DEVELOPMENT REVIEW COMMITTEE (DRC) COMMENT REPORT

PROJECT NAME: River Oaks Townhomes

CASE NUMBER: UDP-S20006

REQUEST: Site Plan Level III Review: Conditional Use for Cluster Development with Three Residential Units

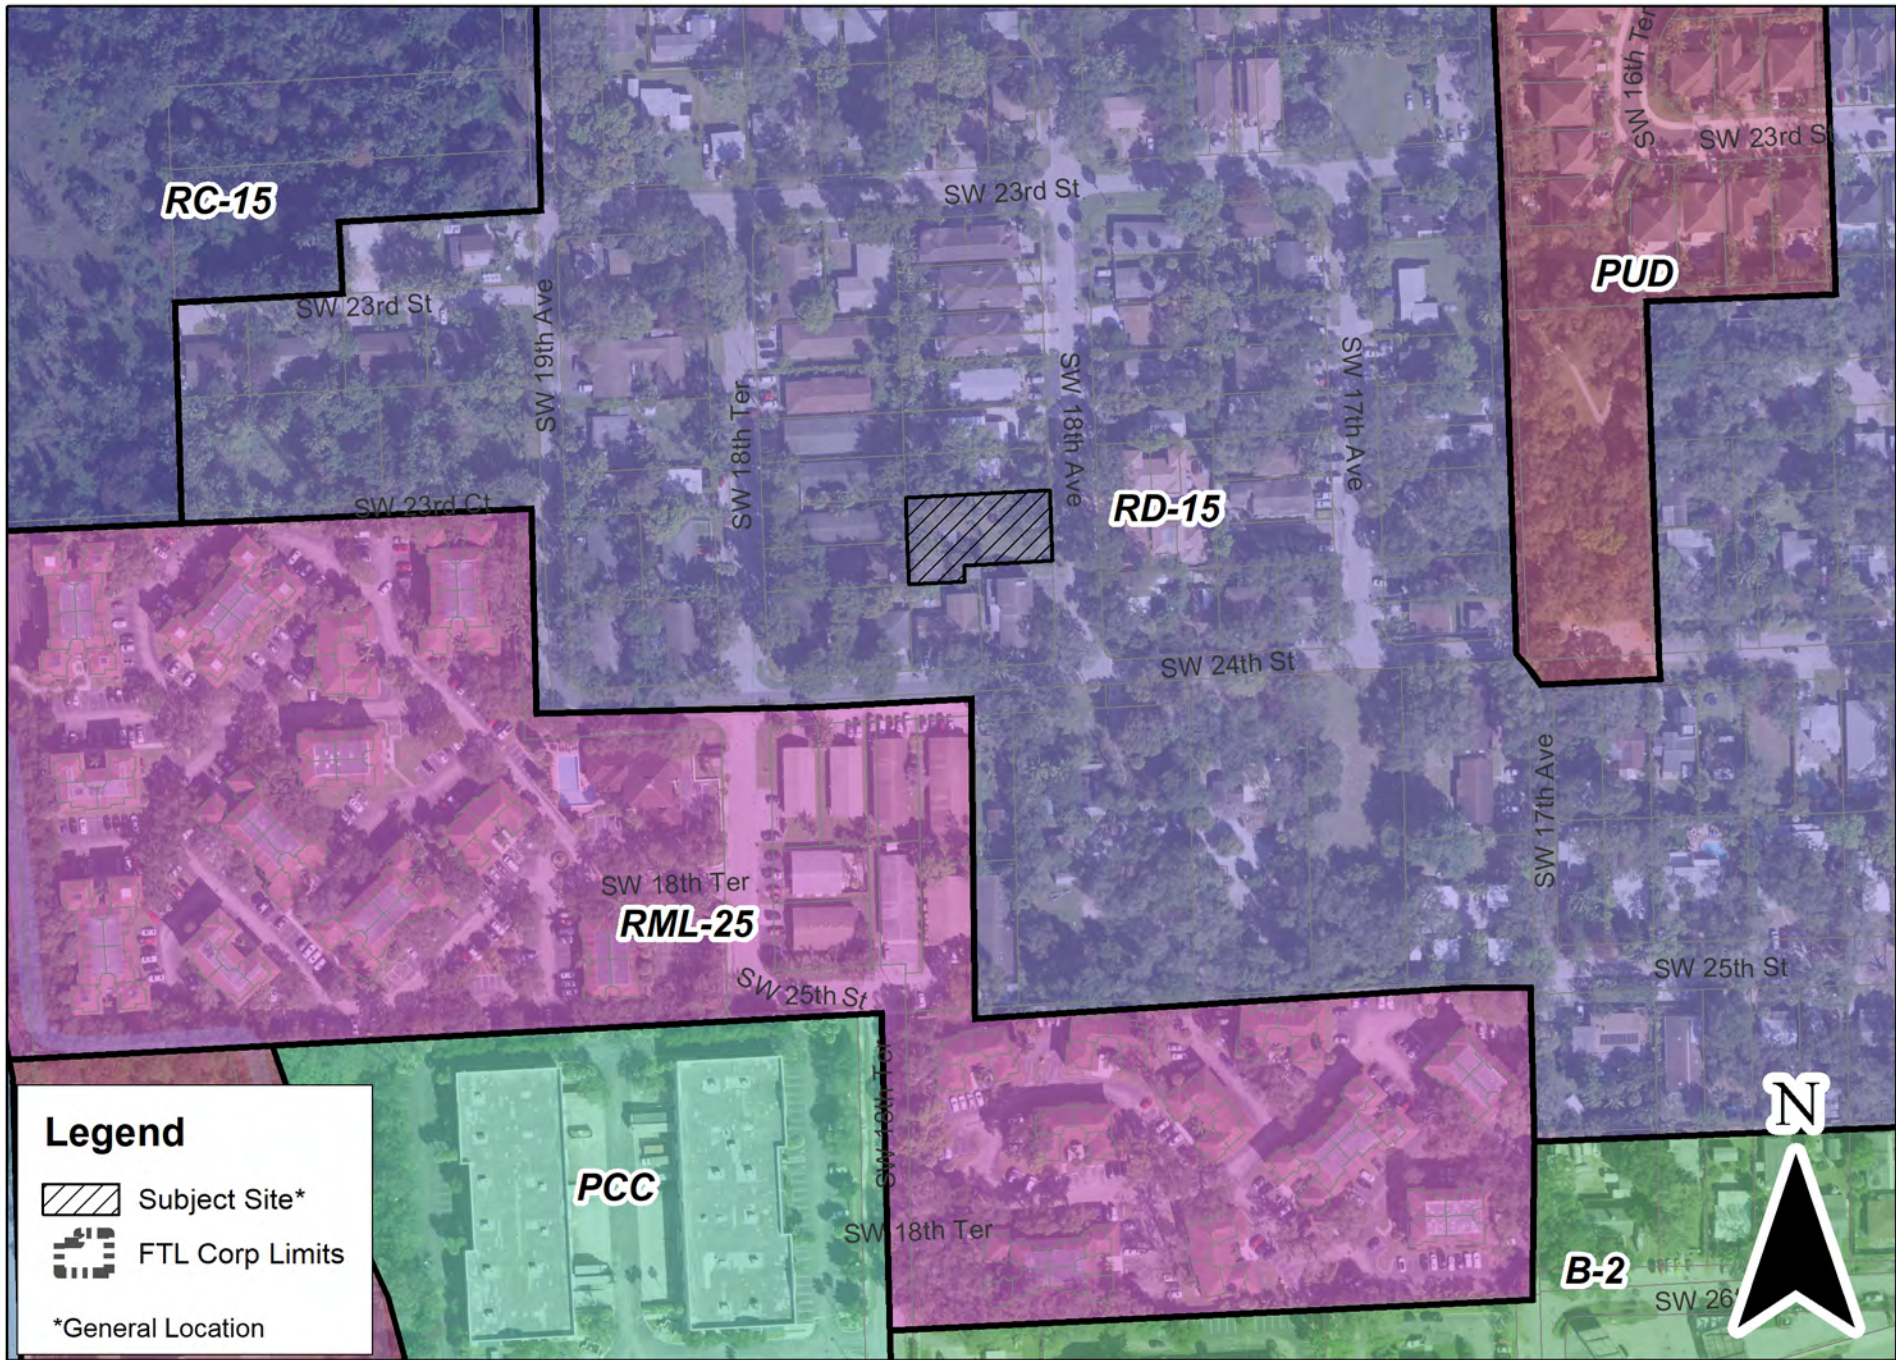
- a) Sec. 47-18.9, Cluster Dwellings
 - b) Sec. 47-25.2, Adequacy Requirements
 - c) Sec. 47-25.3, Neighborhood Compatibility Requirements
- 7) Ensure that the proposed additional setbacks for each façade are consistent with the requirements of Sec. 47-18.9.C.4.f, and that the facades are properly labeled on the elevation drawings.

- 8) Per Section 47-18.9.C.5, illustrate that the elevations of the front (east) façade provide a minimum of twenty-five (25) percent of the area in the form of transparent glass.
